City of Killeen

ADDENDUM NO. 2

RFQ 22-42 A&E and Management Services for EOC & Fire Station 4

KISD TRANSPORTATION FACILITY
FKD REPLAT
CONCEPTUAL LAYOUT

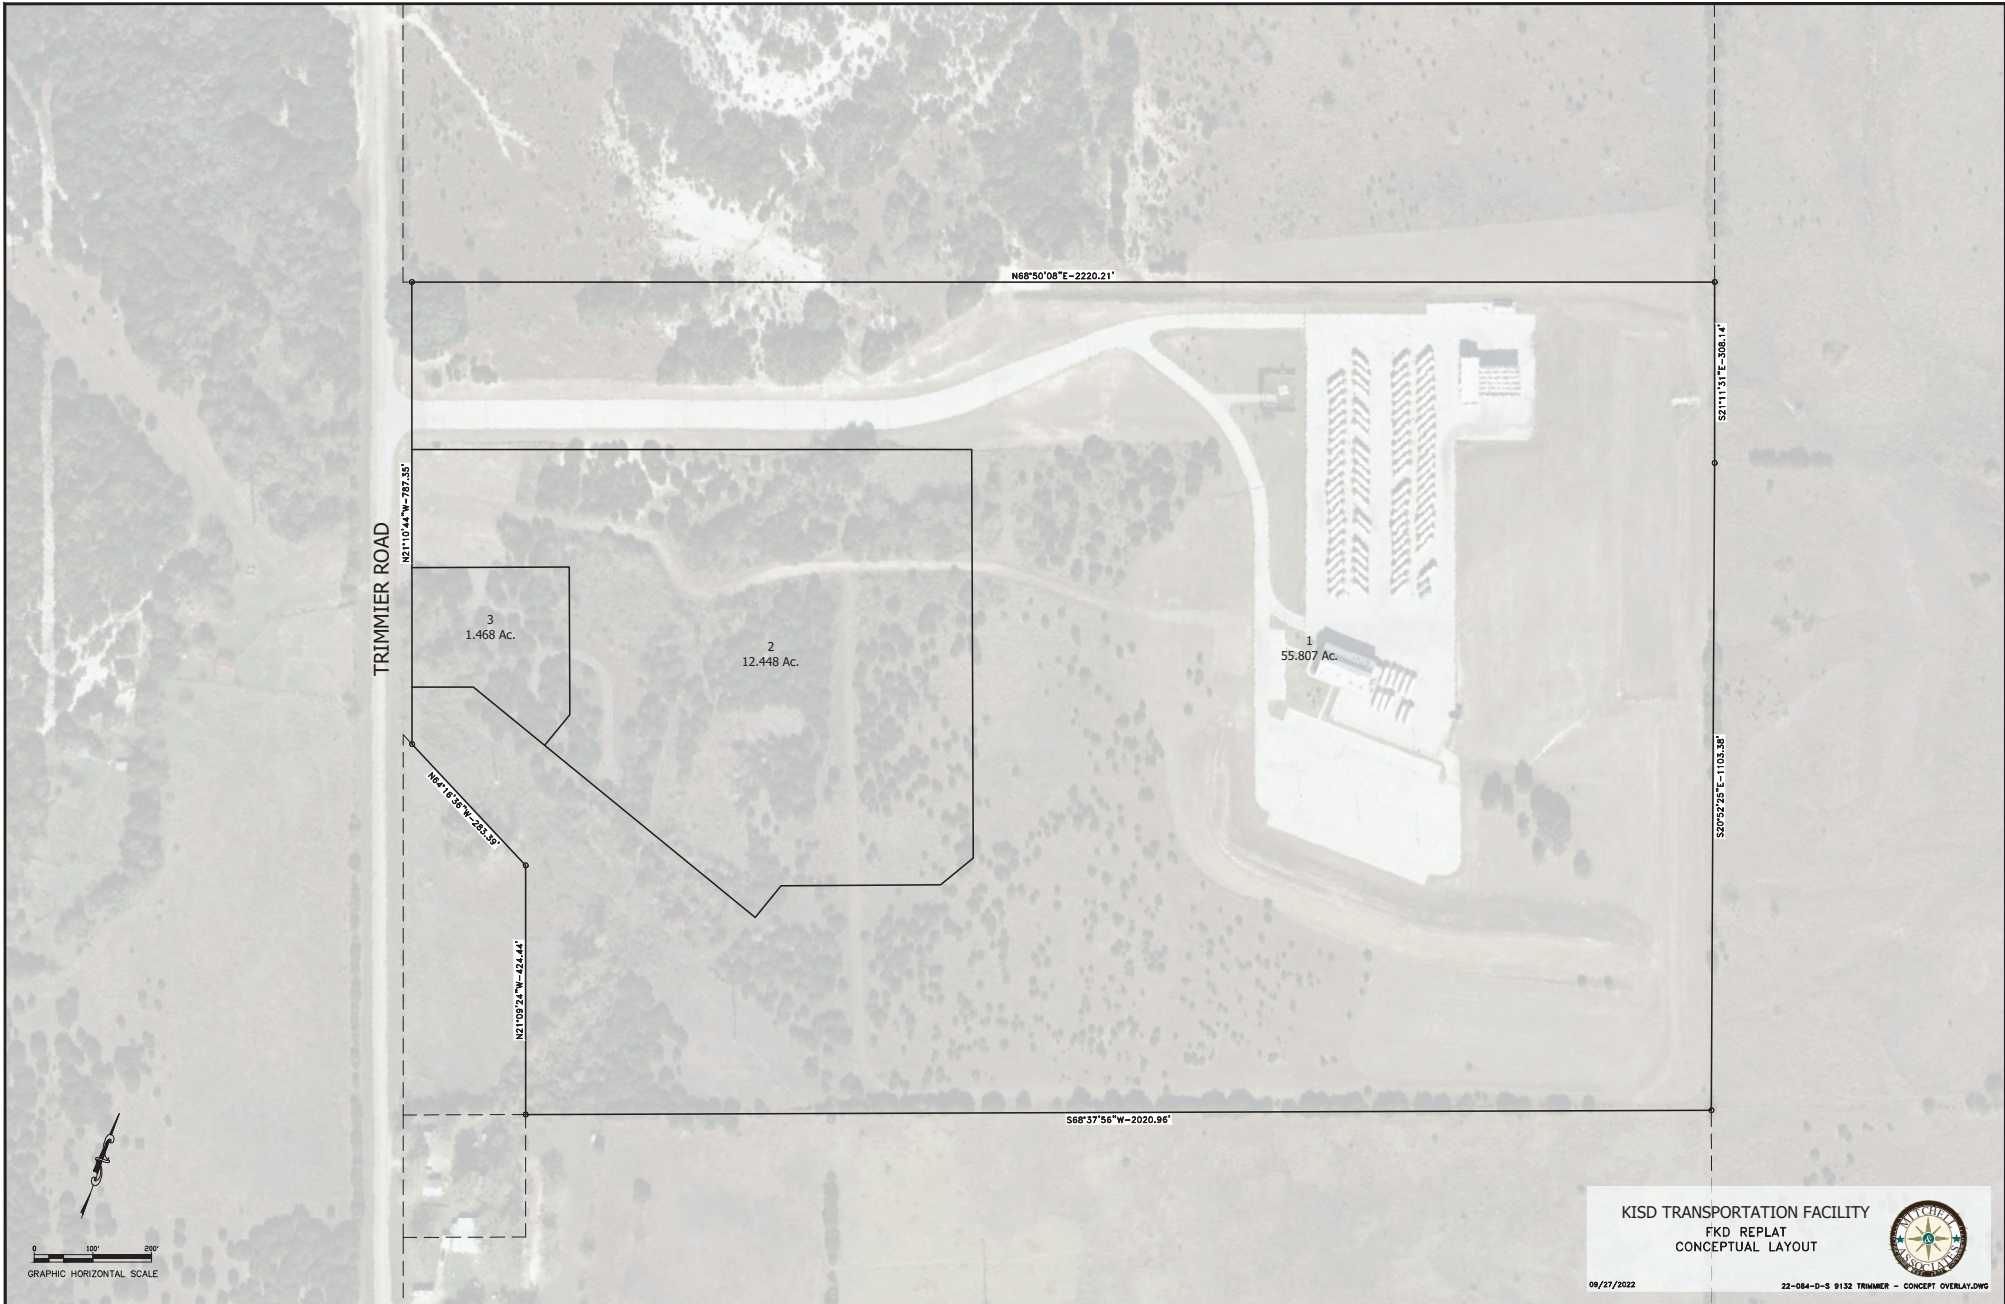
15. Is there an established Program of Requirements (POR), anticipated area (acreage, square footage) of site and building construction, and/or other scope delineation or criteria that can be shared to inform the Statement?

Please see attachment with site layout.
